Access Compliance Report

Public Rights-of-Way

(Curb Ramps)

Intersection ID: 2876	Main Street: AYNRAND_CT	Cross Street: HUNTMEADOW_DR	Location:	N
ADA ID: A8C9ADEB082E	Ramp Type: Perp	Initial Pass/Fail: Fail	Overall Compliance: No	Severity Score: 25

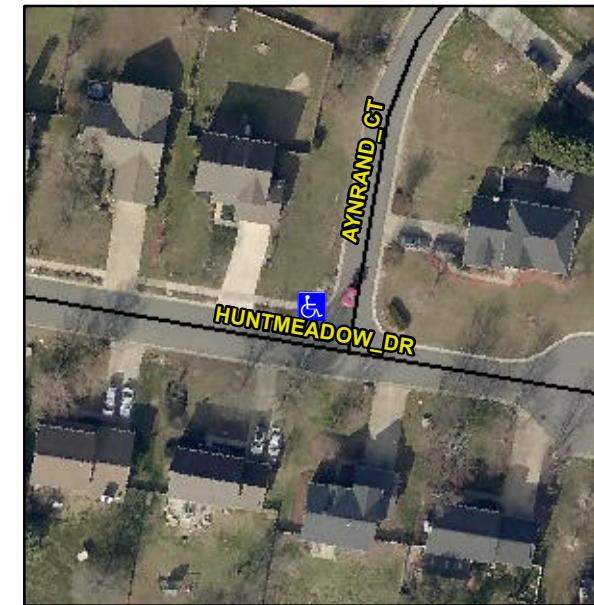
Not Found, R304.5.3

Compliance	Description	Data	Compliance	Description	Data
N/A	Ramp Length (in)	49.0	Yes	Ramp Slope (%)	7.2
Yes	Ramp Width (in)	52.0	No	Ramp XSlope (%)	8.0
N/A	Flare Type LT	N/A	N/A	Flare Type RT	N/A
N/A	Flare Slope LT (%)	N/A	N/A	Flare Slope RT (%)	N/A
N/A	Flare Traversable LT?	N/A	N/A	Flare Traversable RT?	N/A
N/A	Landing Length (in)	N/A	N/A	DWS Provided?	N/A
N/A	Landing Width (in)	N/A	N/A	DWS Contrast?	N/A
N/A	Landing Slope (%)	N/A	N/A	DWS Length (in)	N/A
N/A	Landing X Slope (%)	N/A	N/A	DWS Full Width?	N/A
N/A	Landing Curb? (Y/N)	N/A	N/A	DWS Offset (in)	N/A
N/A	Shared Landing?	N/A			
N/A	Gutter Ponding?	N/A	N/A	Gutter Slope (%)	N/A
N/A	Gutter Lip Ht (in)	N/A	N/A	Gutter X Slope (%)	N/A
N/A	Painted X Walk1?	No	N/A	Painted X Walk2?	N/A
	X Walk 1 Direction	To E		X Walk 2 Direction	N/A
N/A	X Walk 1 Width (in)	N/A	N/A	X Walk 2 Width (in)	N/A
	X Walk 1 Slope (%)	5.1		X Walk 2 Slope (%)	N/A
	X Walk 1 X Slope (%)	3.4		X Walk 2 X Slope (%)	N/A

Remove & Replace Entire Ramp.
